Draft Final Decision Document
 for the Interim Response Action
 for the Improvement of the North Boundary System
 at Rocky Mountain Arsenal
 Via Construction of Groundwater Recharge Trenches

June, 1988

RESPONSE TO US EPA REVIEW COMMENTS
ON PROPOSED DECISION DOCUMENT FOR
THE INTERIM RESPONSE ACTION FOR THE
IMPROVEMENT OF THE NORTH BOUNDARY SYSTEM
AT ROCKY MOUNTAIN ARSENAL VIA CONSTRUCTION
OF GROUNDWATER RECHARGE TRENCHES

STATE COMMENTS ON THE PROPOSED DECISION DOCUMENT FOR THE INTERIM
RESPONSE ACTION FOR THE NORTH BOUNDARY SYSTEM AT ROCKY MOUNTAIN
ARSENAL VIA CONSTRUCTION OF GROUNDWATER RECHARGE TRENCHES, APRIL,
1988

Figure 3. Generalized Alluvial Groundwater Flow Across RMA

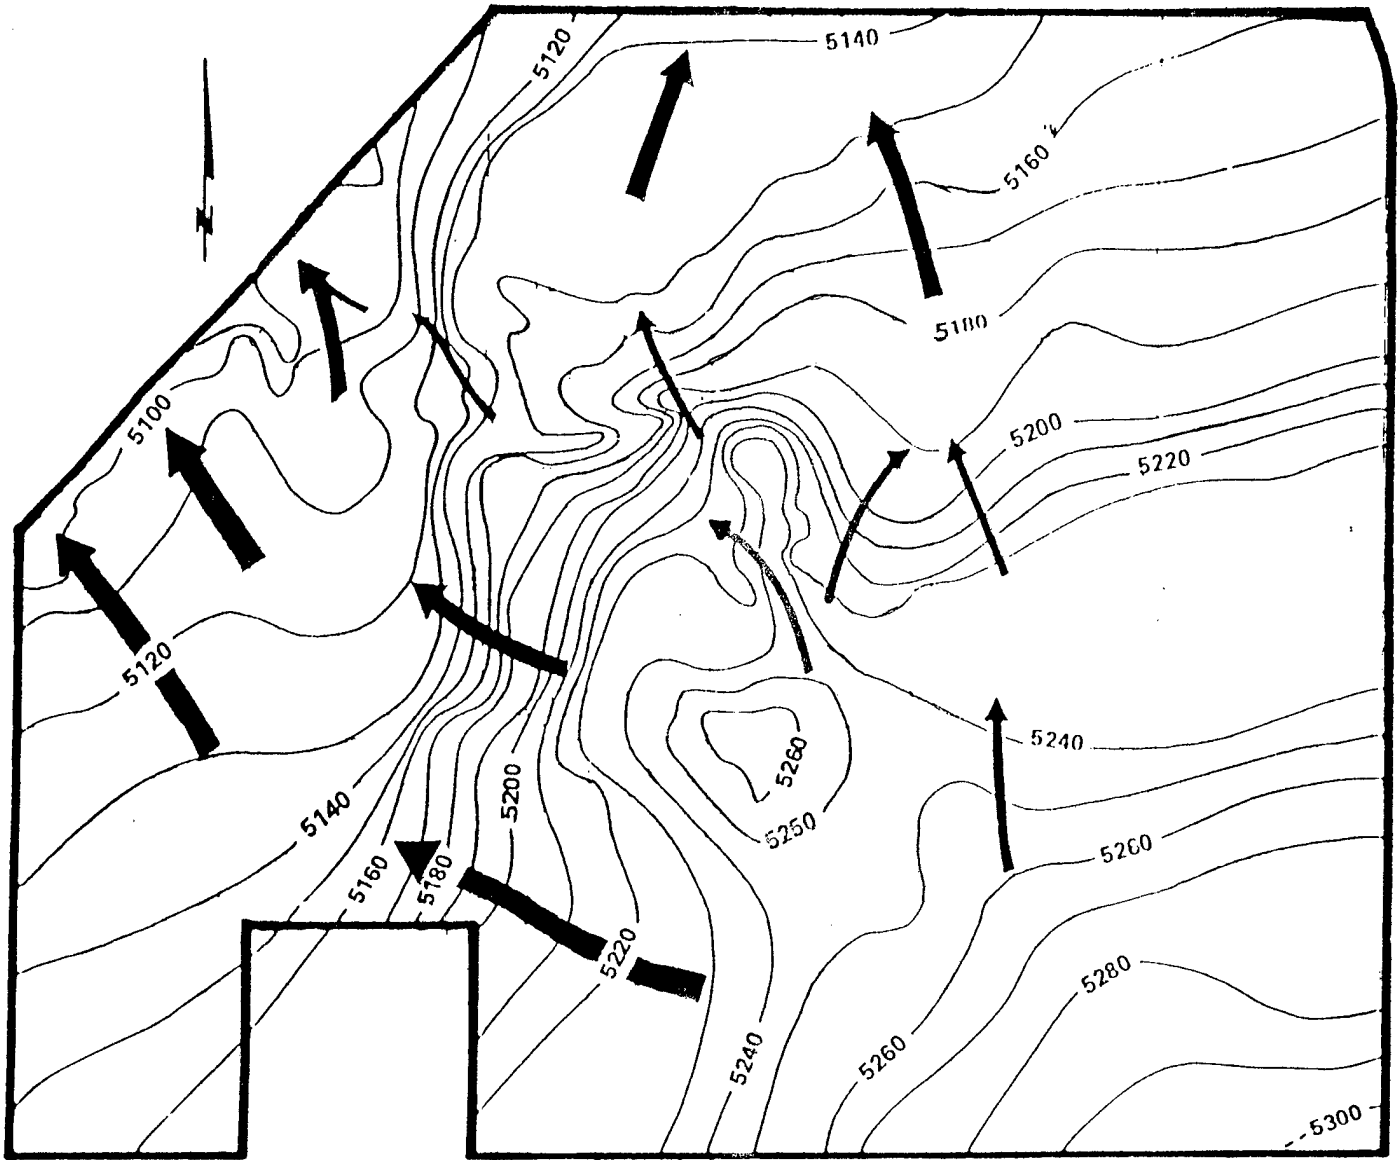
3. Pg. 2, para. 3. The second sentence should indicate that, generally alluvial groundwater beneath RMA flows from southeast to northwest and that Figure 3 represents generalized alluvial groundwater flow across RMA. Emphasis added.

4. Pg. 5, Figure 3. See Specific Comment ³/₅.

3. Page 2, paragraph 3. Emphasize text to clarify generality.

4. Page 5, paragraph 3. See specific comment 3.

Response: The text shall be modified as follows: "Alluvial groundwater beneath RMA generally flows from southeast to the northwest. Figure 3 represents the generalized alluvial groundwater flow across RMA."

Response: The description for Figure 3 shall be modified as follows: "Generalized Alluvial Groundwater Flow Across RMA."
